REMARKS

This AMENDMENT UNDER 37 CFR 1.111 is filed in reply to the outstanding Office Action of March 14, 2003, and is believed to place this case in condition for allowance for the following reasons.

1/9
THOMAS W. DYER, et al.
F1S920000337US1 (TMCL)

FIG. 1A PRIOR ART

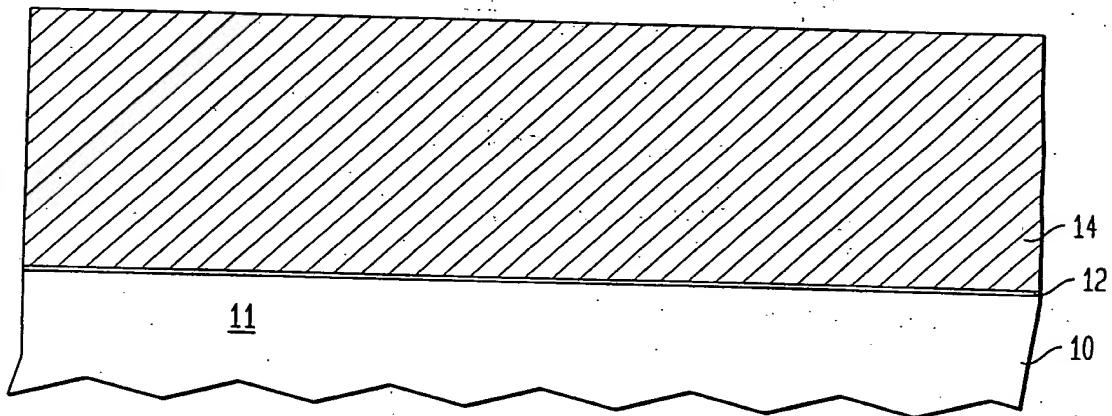
OK
Initially, substitute Figures 1A, 1B, 1C, 1D, 1E and 1F are attached hereto which add the legend PRIOR ART thereto, as proposed in the previous AMENDMENT.
